Planning and Assessment Commission - D493/17 Objection to Wambo Modification 17

UNITED WAMBO OPEN CUT COAL MINE PROJECT

COMMENTS ON SUBSIDENCE, GROUNDWATER AND SURFACE WATER ASSESSMENTS, WAMBO MOD 17

Figure 2 – Longwall extraction depths and cross sections (from EA 03 MSEC Dwg 848-05 and EA 02 Figures 1.2, 1.3 and 1.4)

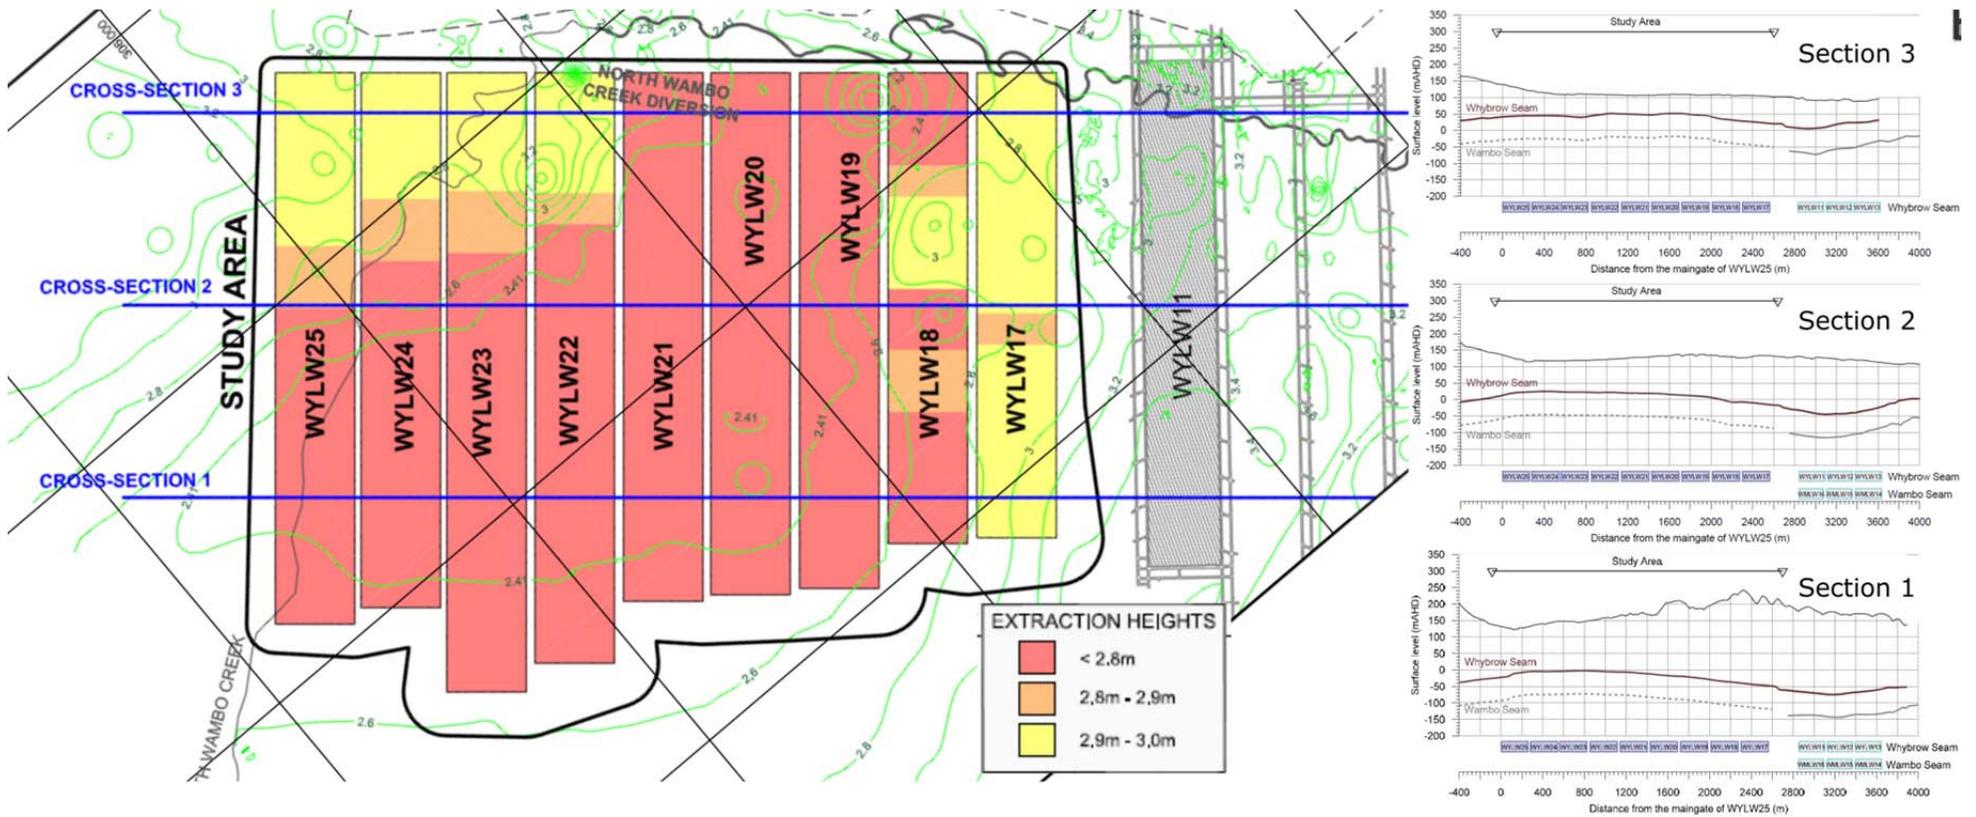
The locations of the proposed longwalls are shown in Figure 1. The thickness of extraction and cross-sections through the panels are shown in Figure 2 and are indicative of relatively low depths of cover (as shallow as 50 metres) and high extraction heights (generally in the order of 3 metres). This is expected to result in relatively large subsidence - as shown in Figure 3 subsidence up to approximately 2 metres is predicted in the EA. The subsidence predictions were made by MSEC

Figure 4 – Natural features above longwalls (from EA 03 MSEC Dwg 848-08)

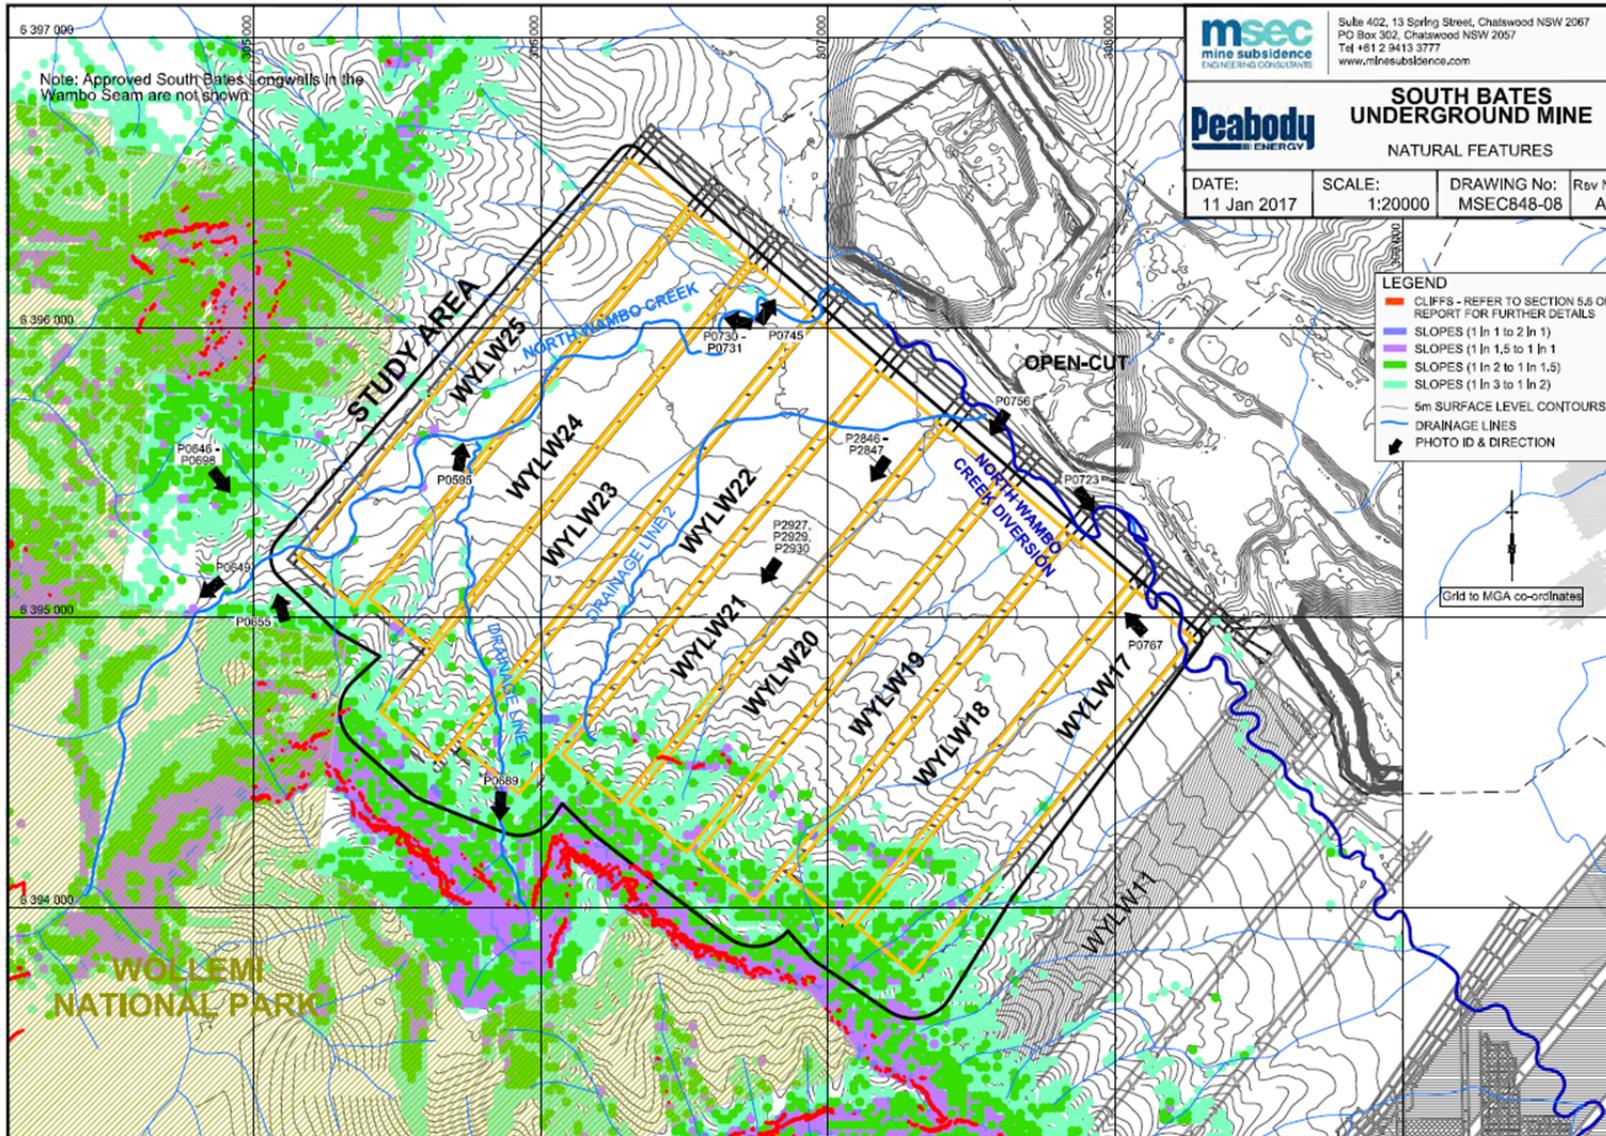
Natural features above the longwall include the natural (undiverted) section of North Wambo Creek and tributaries, as shown in Figure 4. An excerpt from EA 02 (pg 36) describes North Wambo creek as follows:

It is clear that the extent of subsidence and cracking is such that it would greatly disturb the natural values of North Wambo Creek. The predicted changes to stream gradient, extensive bed cracking, and drawdown of adjacent water table by up to 55 metres are all significant impacts. While it is not our role to make a determination of the acceptability of these impacts, it is emphasised that these impacts to North Wambo Creek are severe.
